Development Permit Panel

Re: Application by Omicron Architectural Engineering Construction Ltd. for a
General Compliance Ruling at 15111 Williams Road and Richmond Key 195105

Overlay Plan Showing The Existing And Proposed Pierson Road Alignment

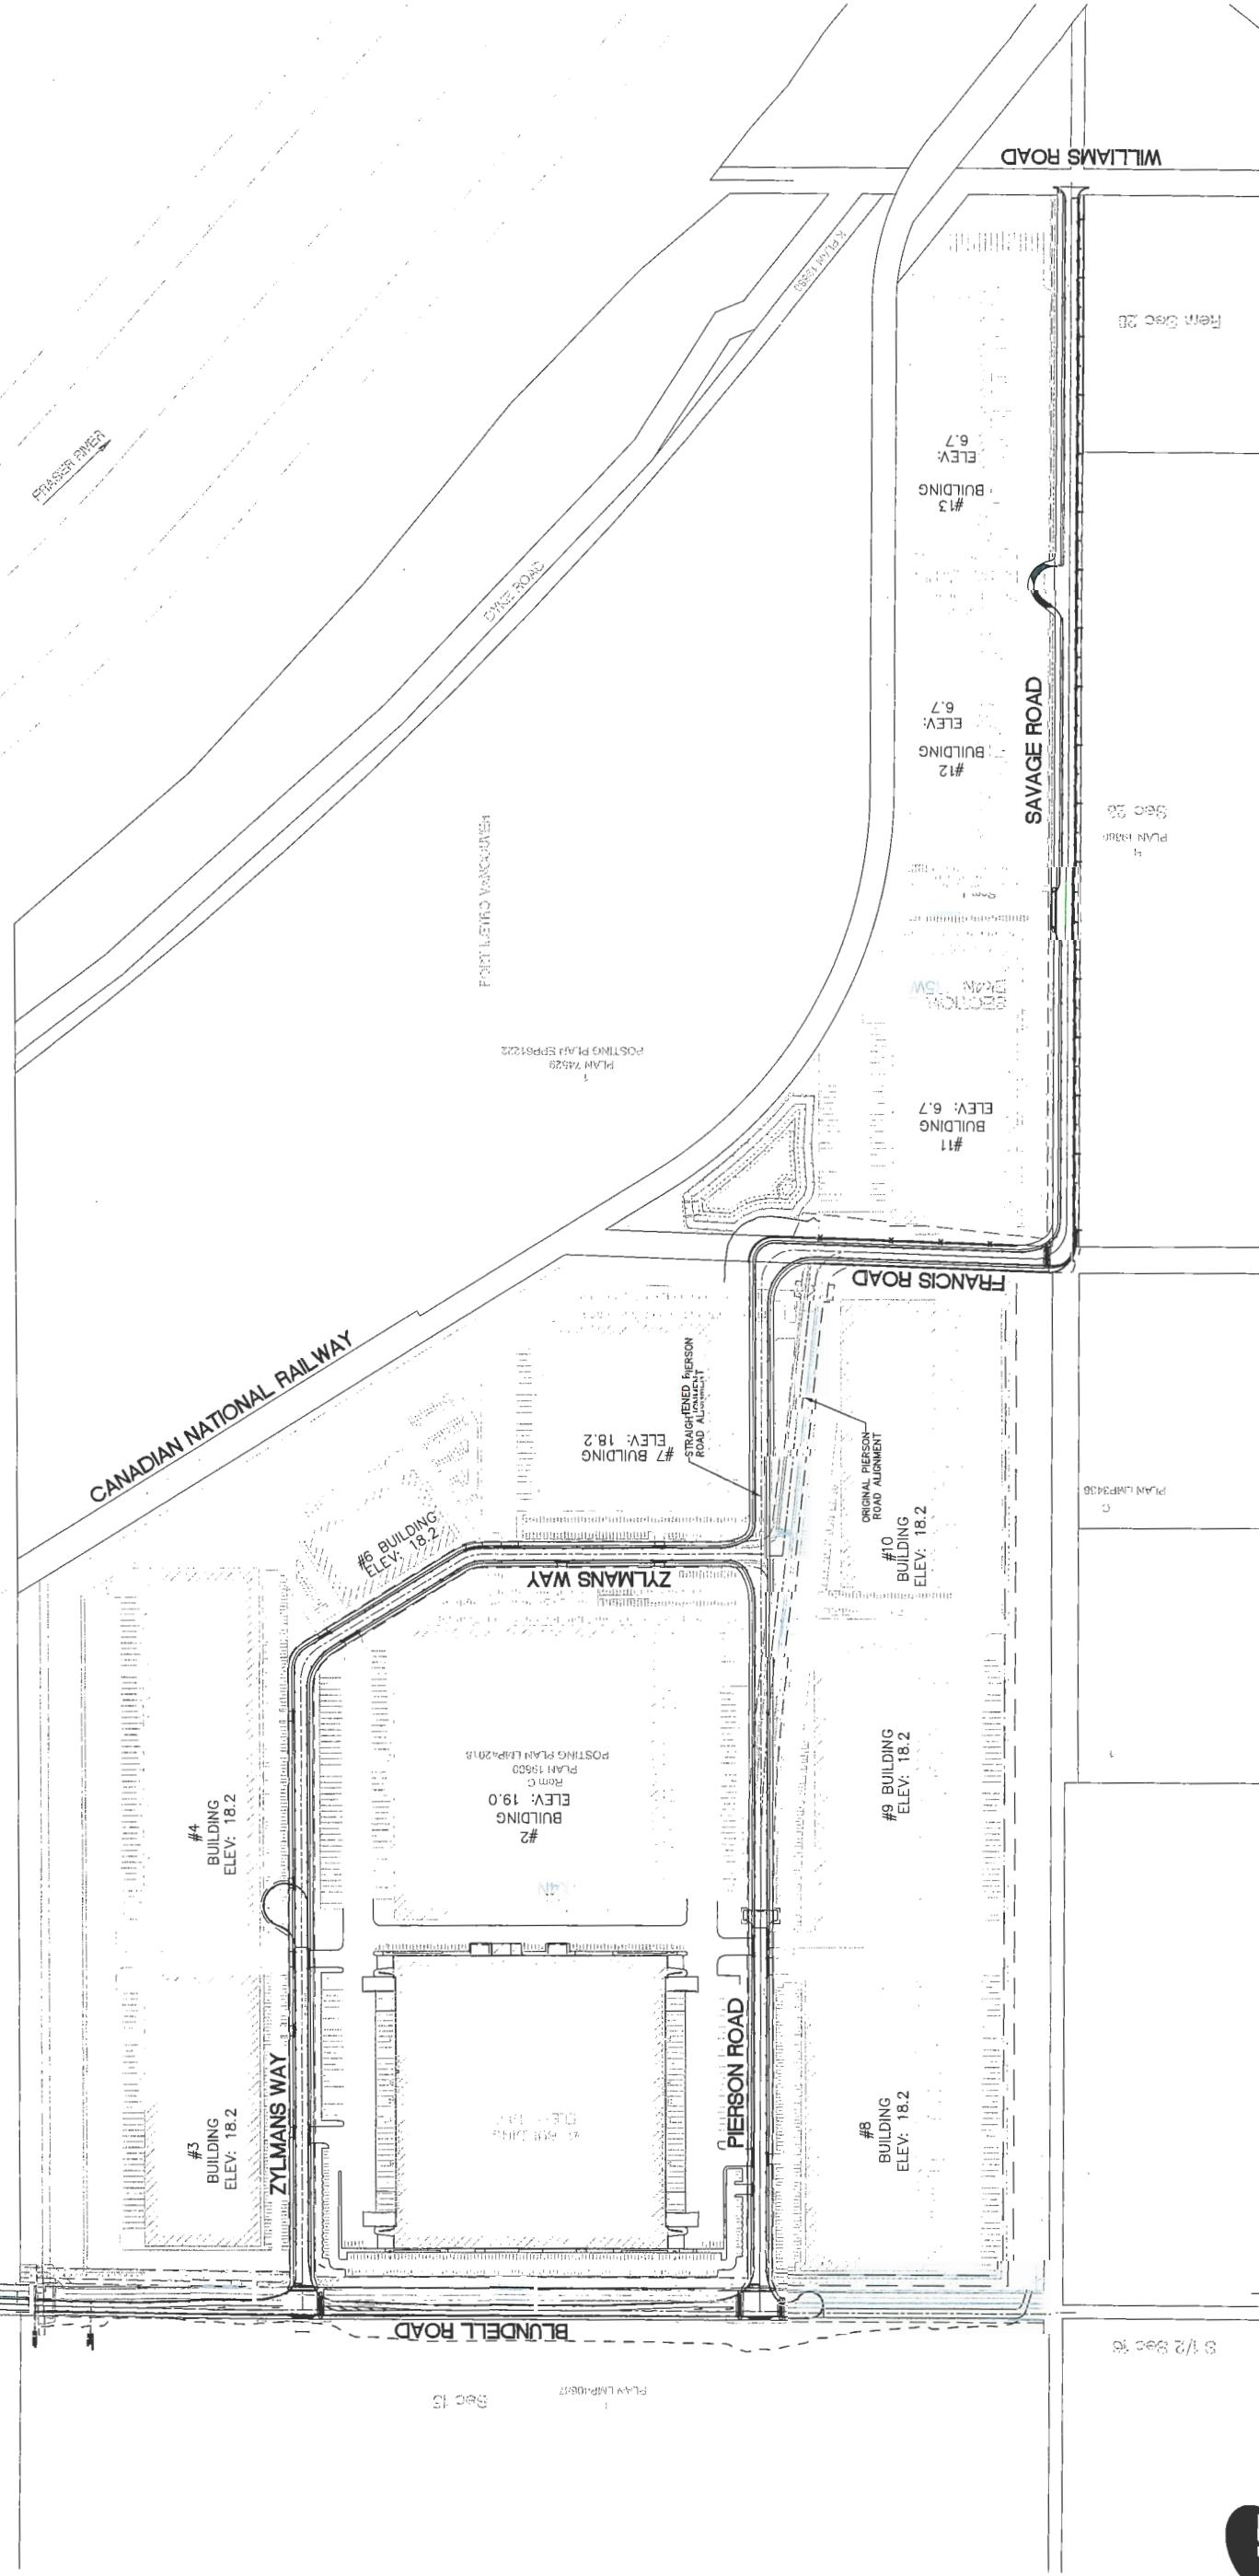
1. Straightening Pierson Road by shifting the southern end approximately 40 m to the east (Attachment 2). Modifications to the statutory right-of-way (SRW) legal documents and the related Servicing Agreement plans (SA13-641028, SA14-677209, SA16-737220) will be required to reflect the change in alignment and the associated works (e.g. frontage improvement relocations, fill adjustments, off-site landscaping, etc.).

The proposal involves moving the southern end of Pierson Road approximately 40 m to the east; allowing for a straightening of Pierson Road between Blundell Road and Francis Road. See Attachment 2 for an overlay showing the existing and proposed Pierson Road alignment. The rationale for straightening Pierson Road is to allow for more efficient use of the land base.

DEVELOPMENT PHASING PLAN

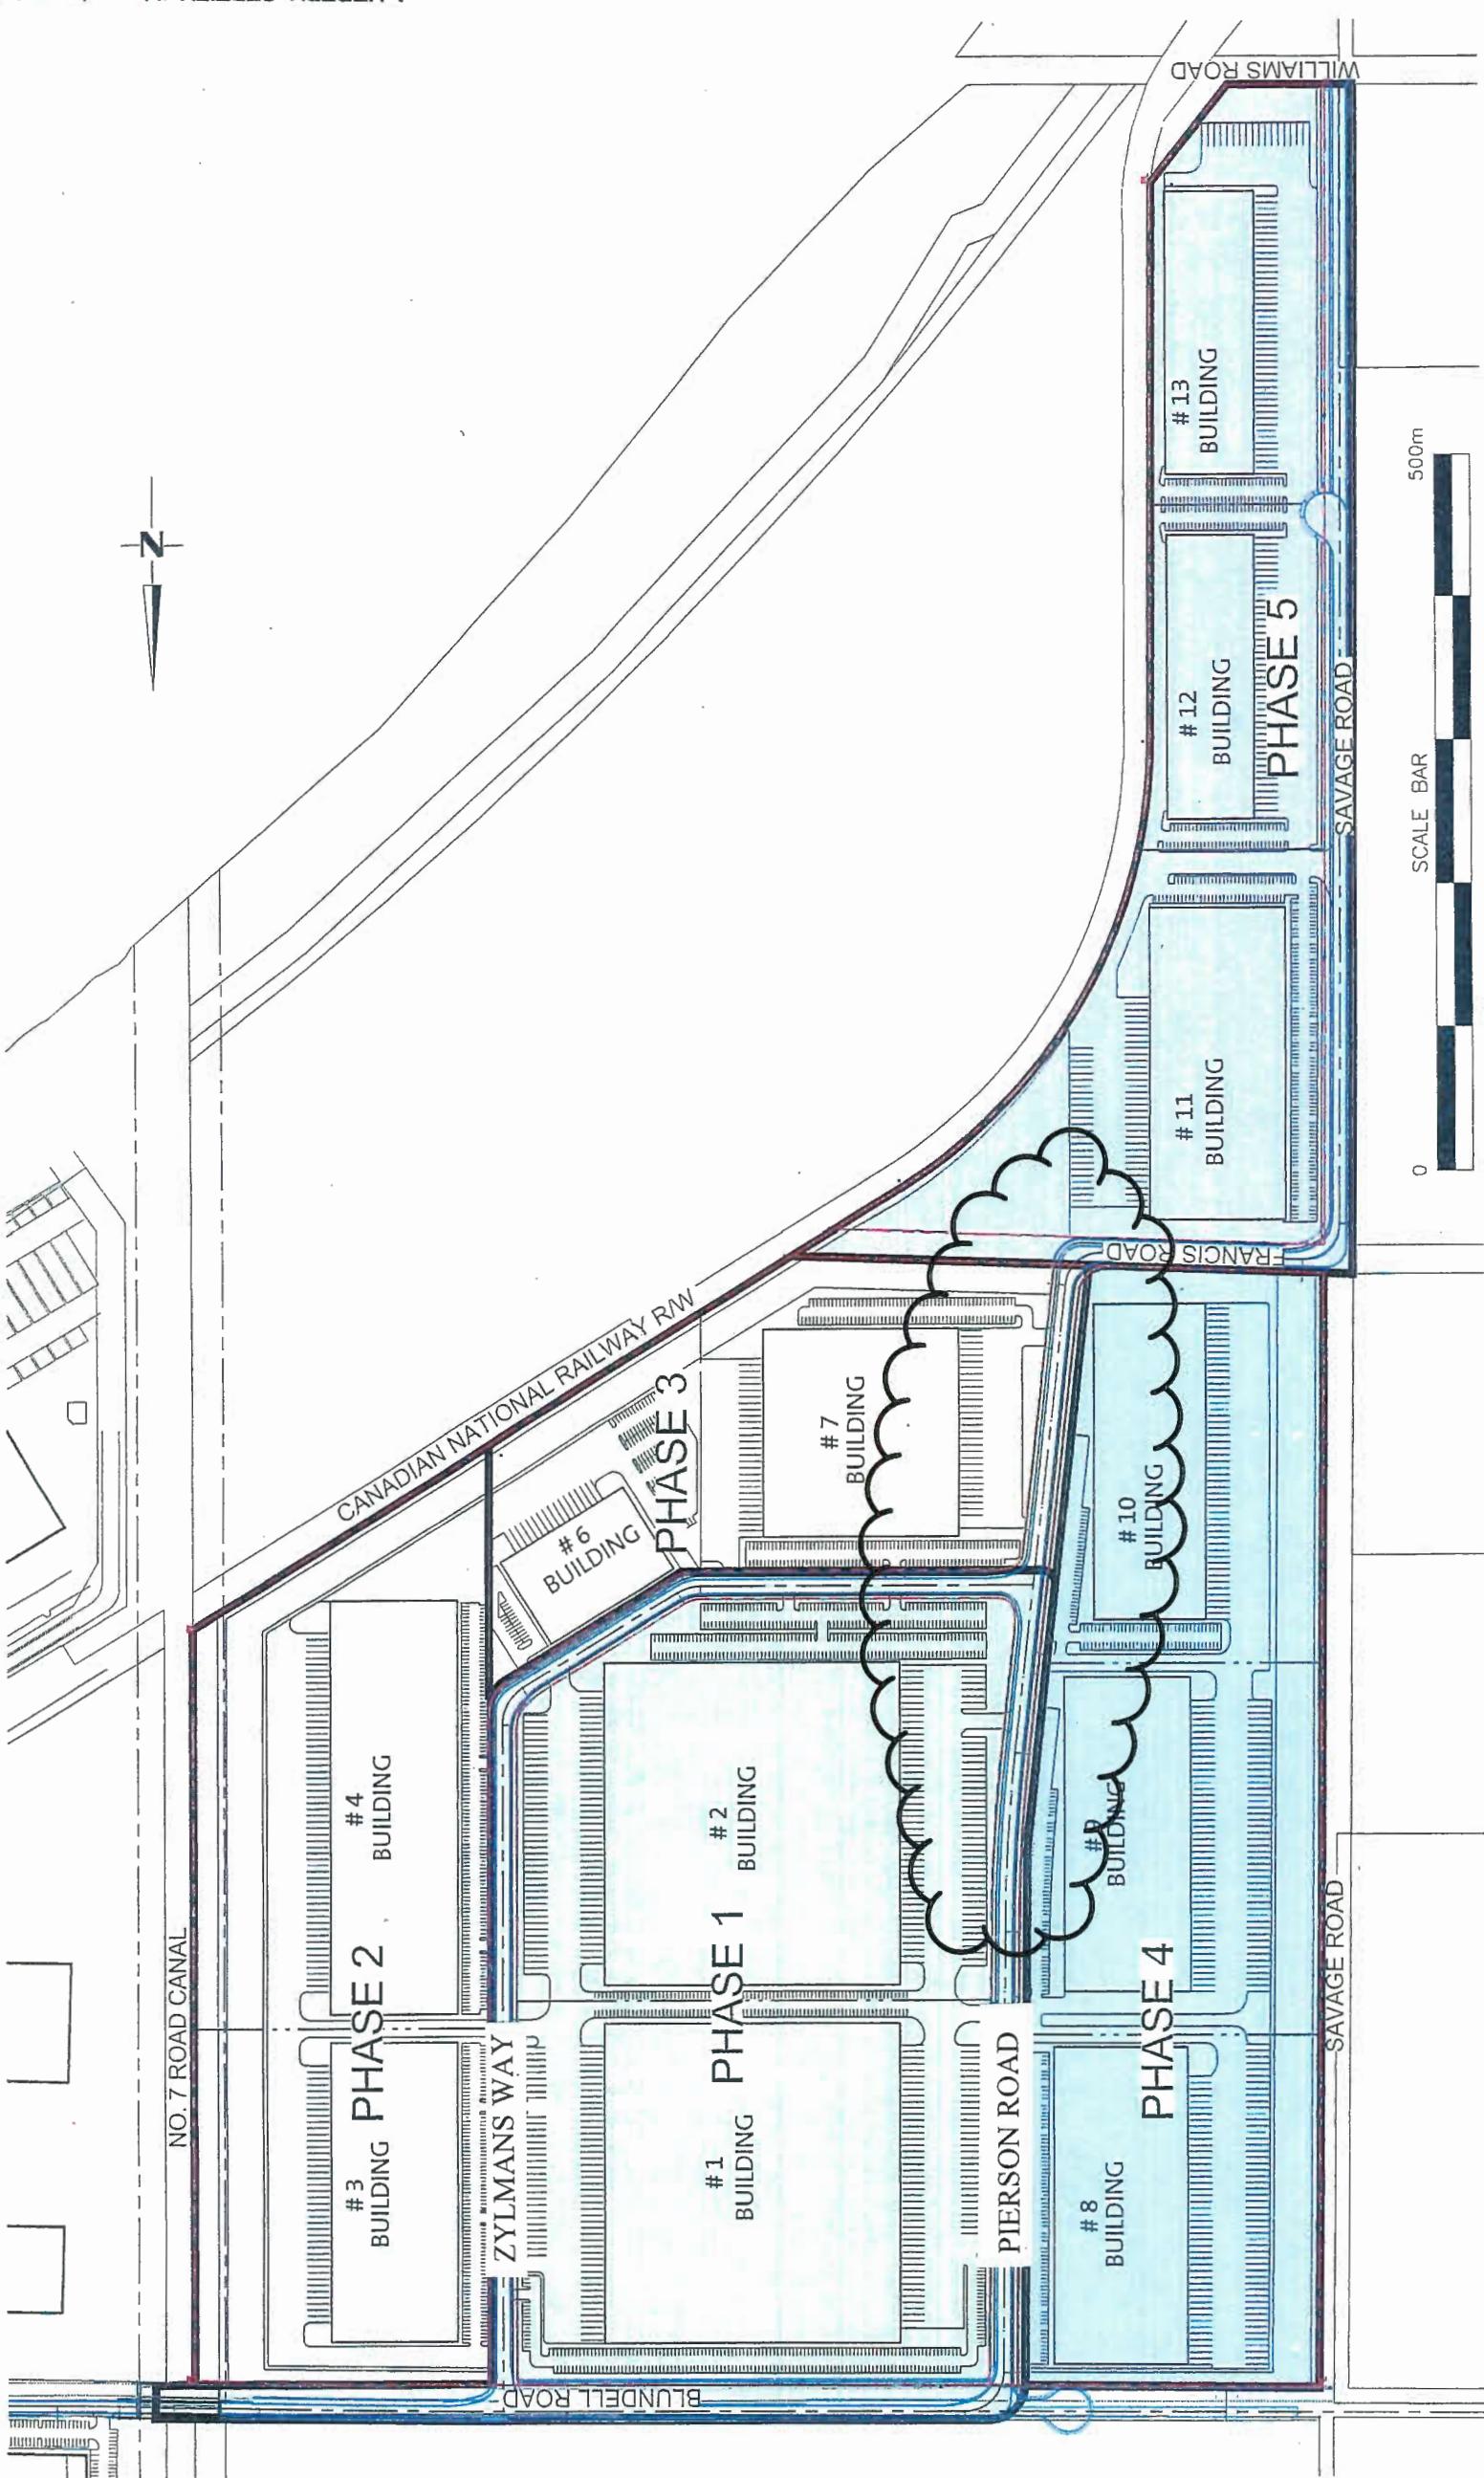
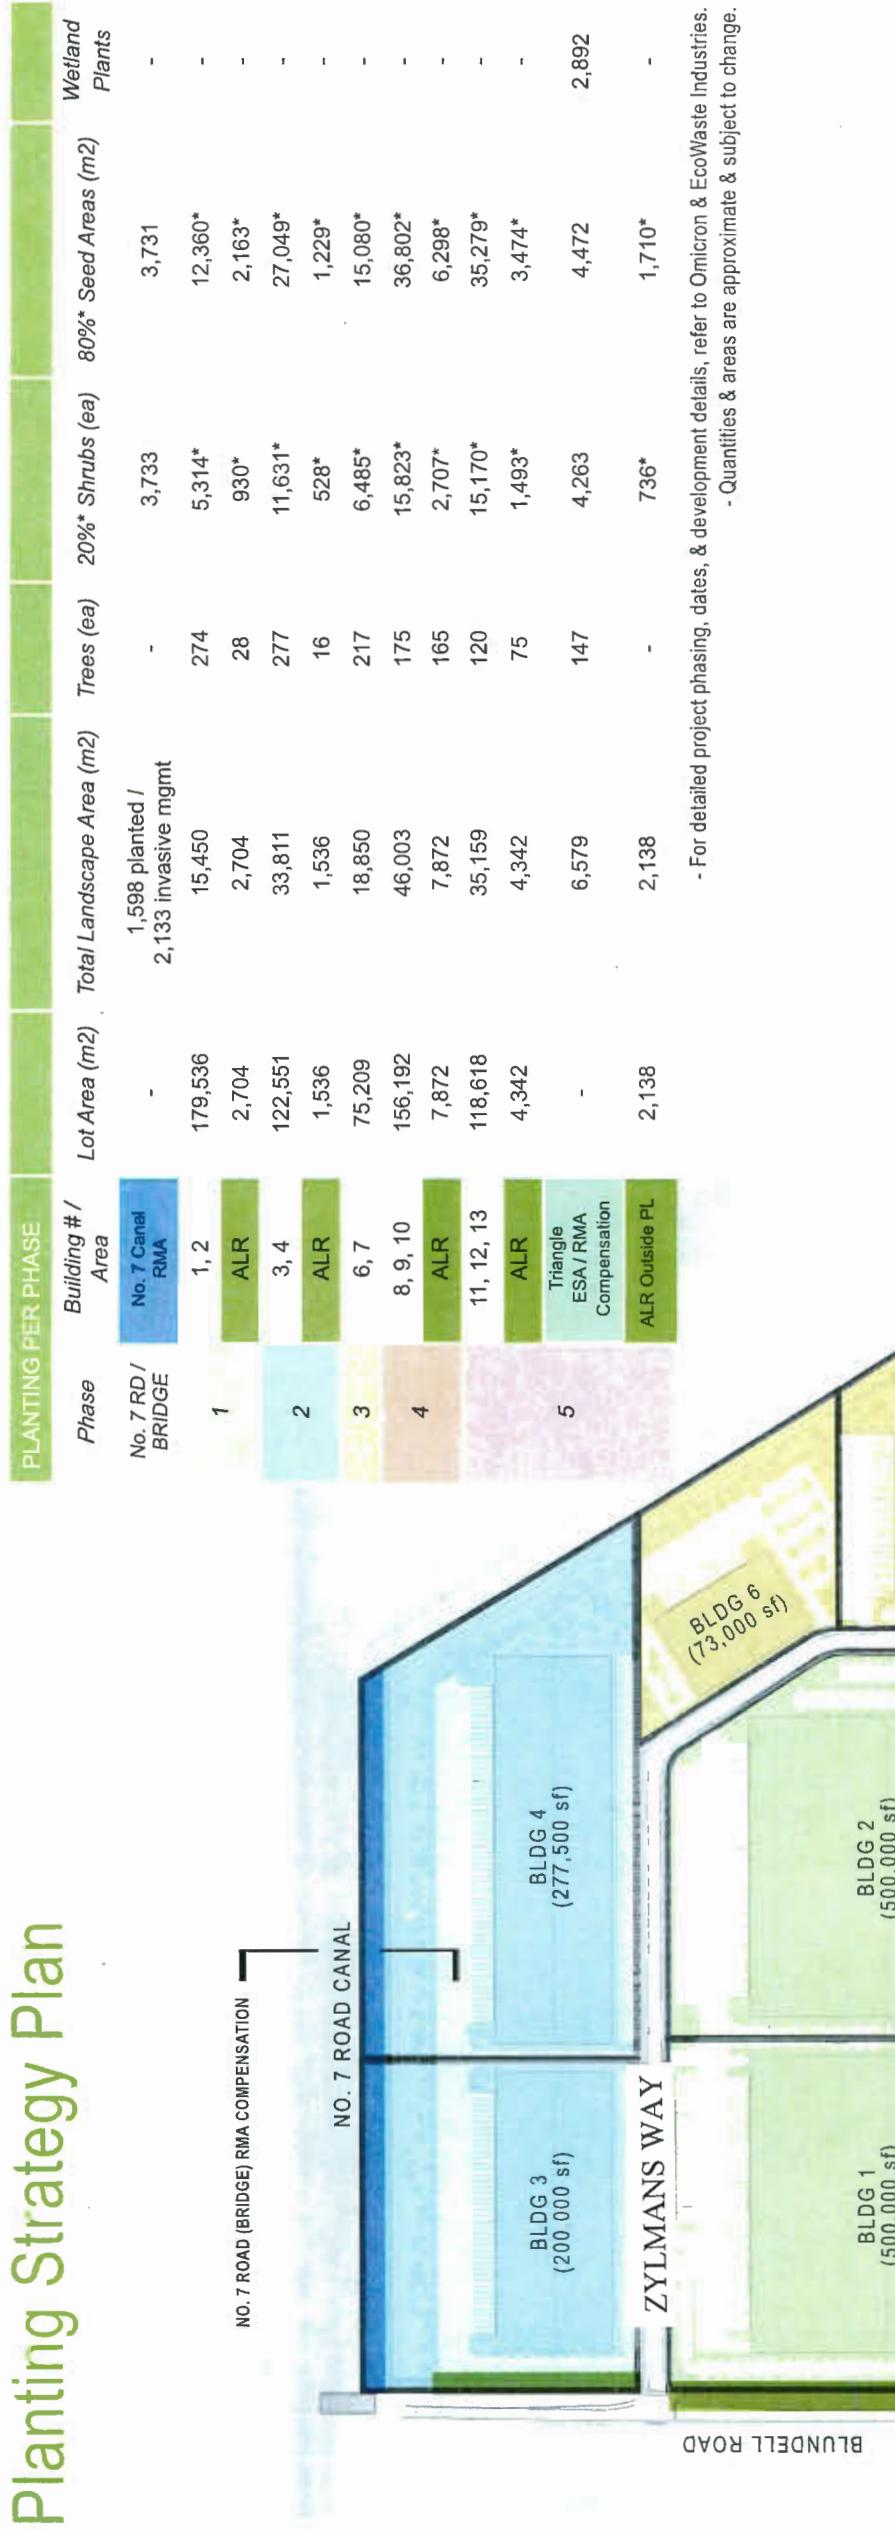
Building footprints and parking layouts for the proposed developments adjacent to Pierson Road, particularly for areas in vicinity of buildings #2, 7, 9 and 10 (as shown on the Development Phasing Plan in Attachments 3 and 4), will be significantly improved with the more regular lot shapes. Neither Engineering staff nor Transportation staff have concerns with the Pierson Road realignment and these roads will be reviewed through amendments to the current Servicing Agreements.

In the proposed revised conceptual layout, five building lease lot areas and three building footprints would be adjusted. The adjustments will result in a relatively small increase in the site’s total floorspace of approximately 743 m^2 ($8,000 \text{ ft}^2$) for an overall build out total of approximately $266,678 \text{ m}^2$ ($2,870,500 \text{ ft}^2$). What this modest space increase does not convey is the more important aspect of improved and more useable building footprints which will be more attractive to today’s high tech industrial users. Even with the proposed overall floorspace to

While parking requirements will be determined with each “build to suit” application, the revised conceptual layout appears to be more typical and more efficient in the vicinity of buildings 9 and 10 in particular. The new layout will improve the truck yards for both buildings by making them larger and more flexible for circulation and trailer storage. Actual parking requirements and final layouts will be confirmed with each subsequent Building Permit application.
